Dave Schettler, PE
Schettler Civil Engineering Services LLC
(for Construction Special Inspections)
57 Wedge View Ln
Leavenworth, WA 98826
Phone: (509) 669-5469

December 20, 2023

RE: **VCP Project No: CE0509, Lake Chelan Community Hospital, Facility/Site ID: 66314**
Response Document to Ecology - Mary Monahan's letter dated Dec. 13, 2023
on requested list of more information to be provided for review of VCP Opinion
for a No Further Action Determination

FIGURE C – 4TH SET SAMPLE TEST LOCATIONS
SOIL SAMPLES TESTED FOR ARSENIC & LEAD CONCENTRATIONS 8/11/2023
AT DEPTHS ~ 0.5 FT BELOW FINAL GRADING ELEVATIONS

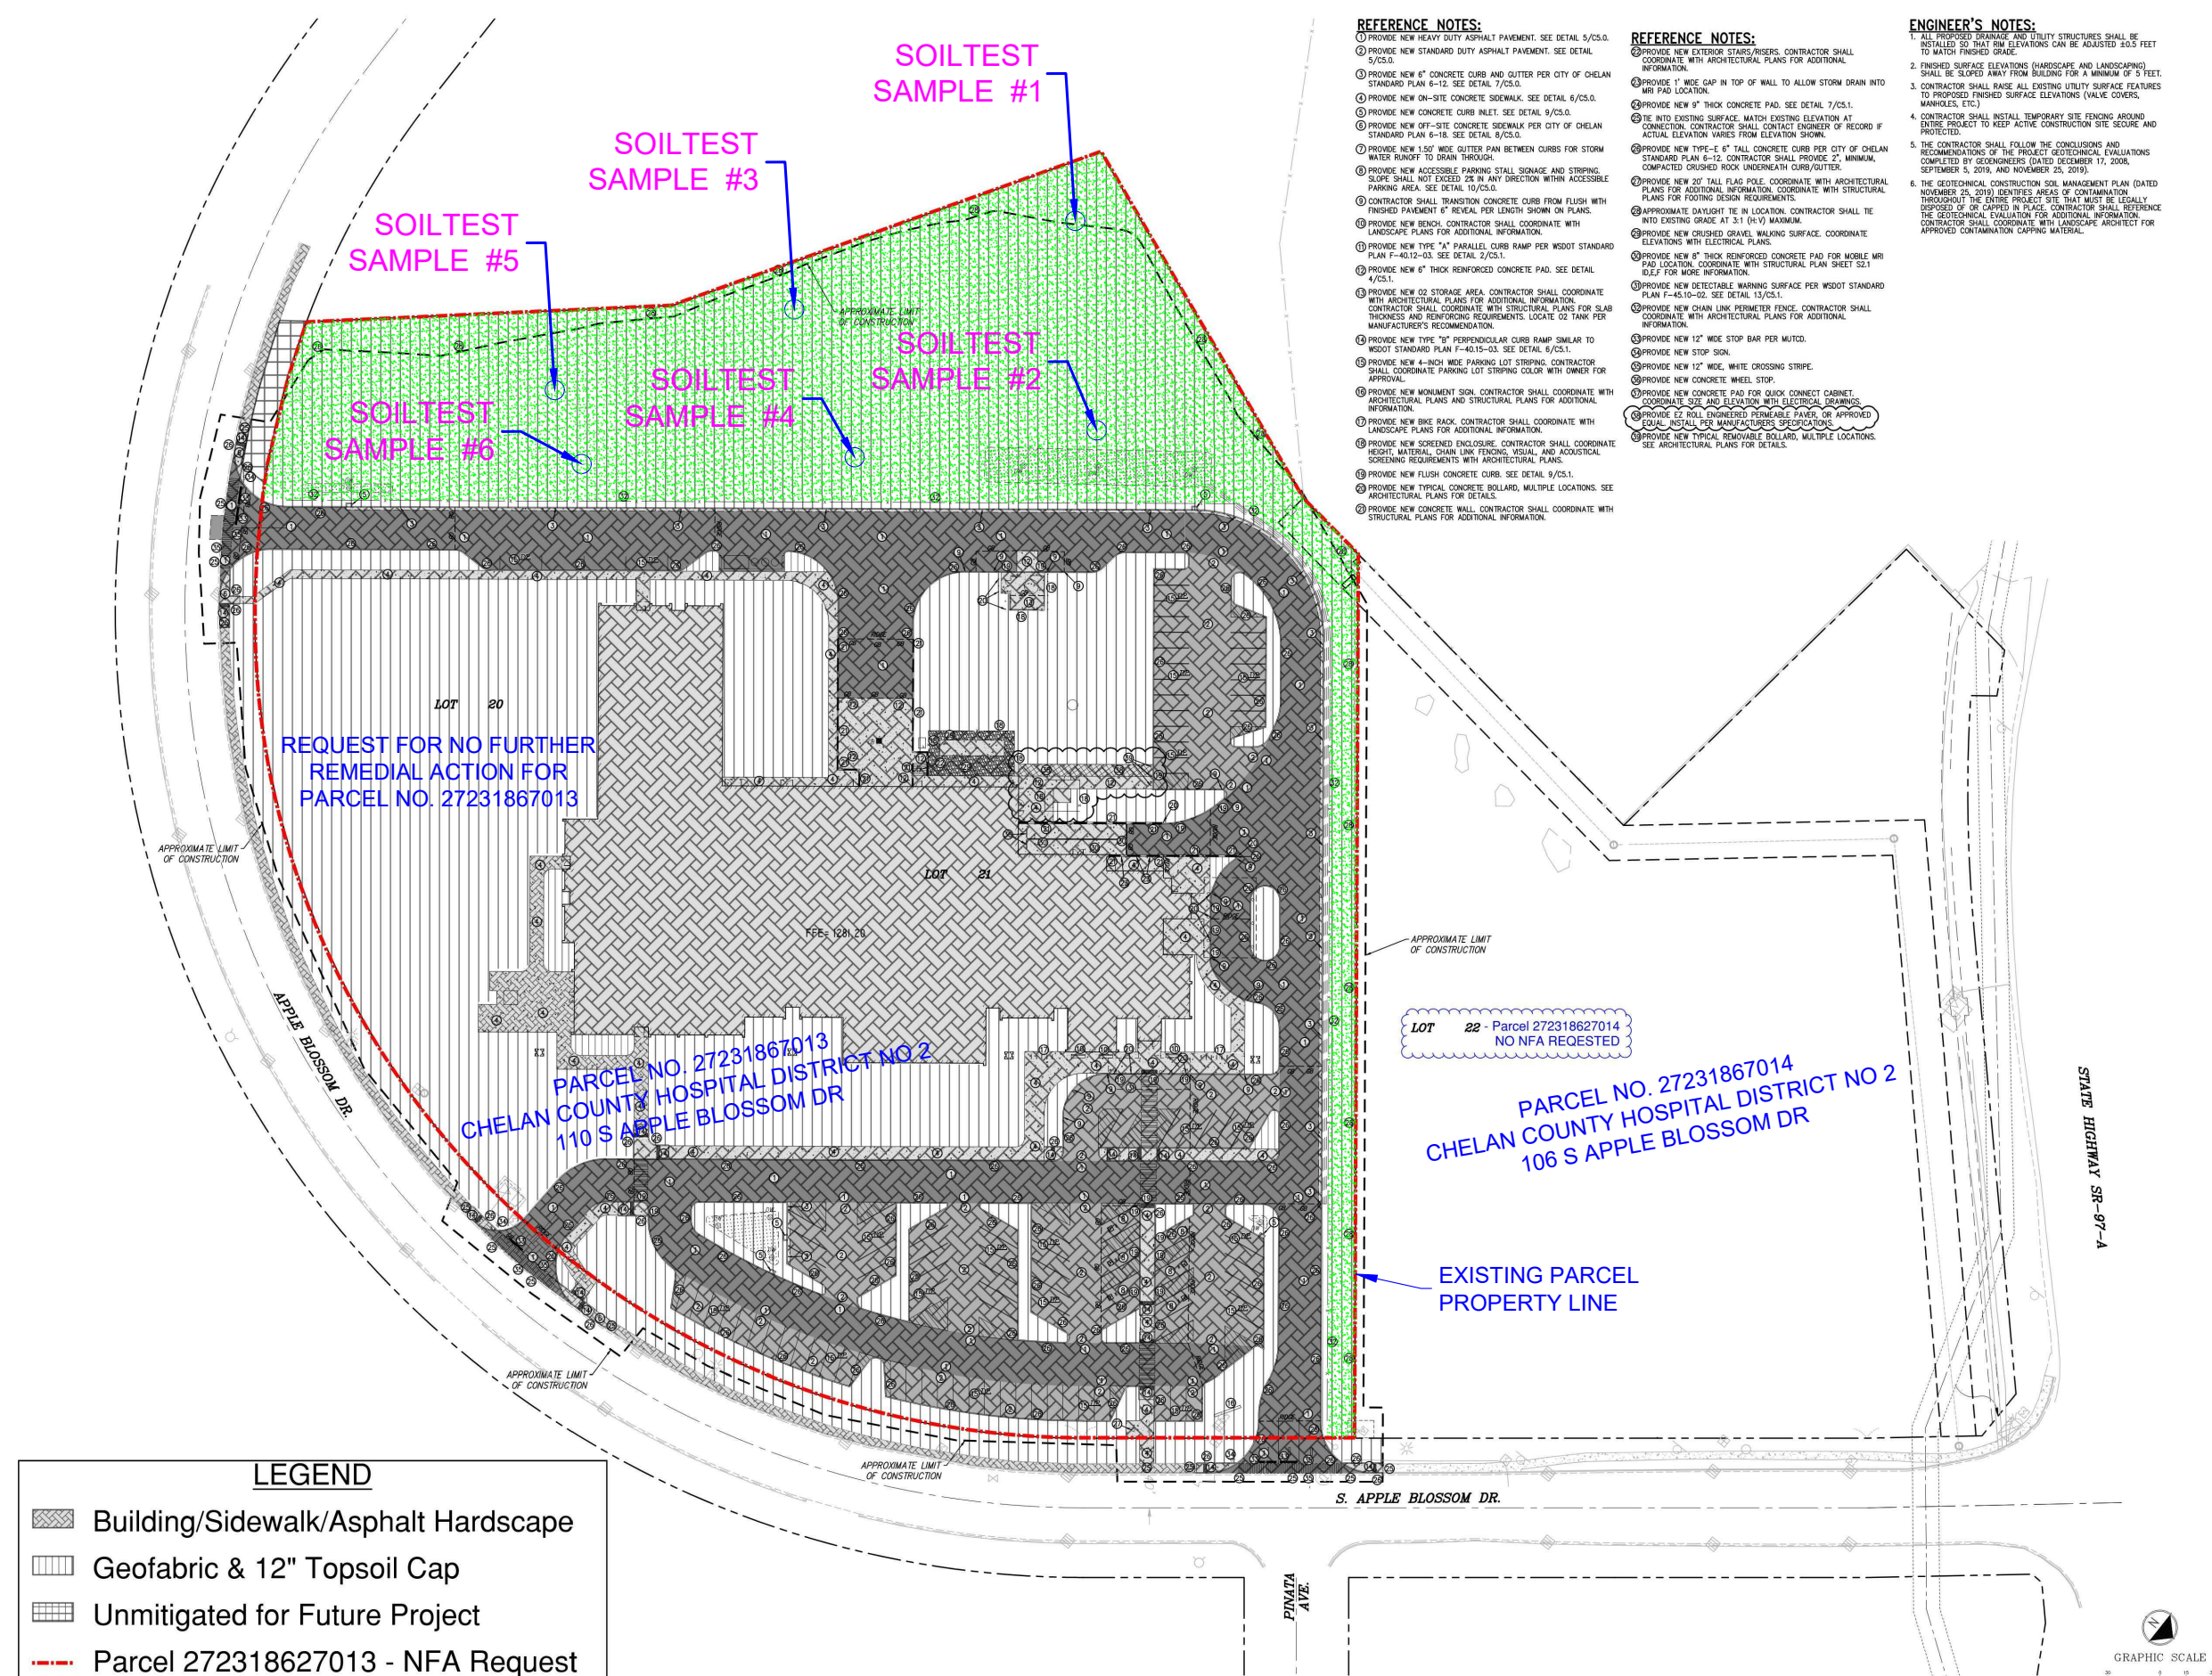
4. All laboratory data sheets from the laboratory, including any quality assurance and chain of custody documentation.

Any data that has not yet been entered into EIM must also be added to EIM. Since our EIM personnel are backed up, if you can provide a confirmatory email that you have submitted additional EIM data, that will be acceptable.

*Response: Attached is the lab data sheets for the recent six (6) soil test samples taken from the remainder of the site area highlighted in green that was required to be capped as shown in attached **Figure C – Site Plan**. The laboratory data sheets also include the Chain of Custody and quality assurance documentation. The test data for these six (6) samples has been entered into Ecology's EIM database (see attached confirmation email from ECY – Nicole Masurat on 12-19-2023).*
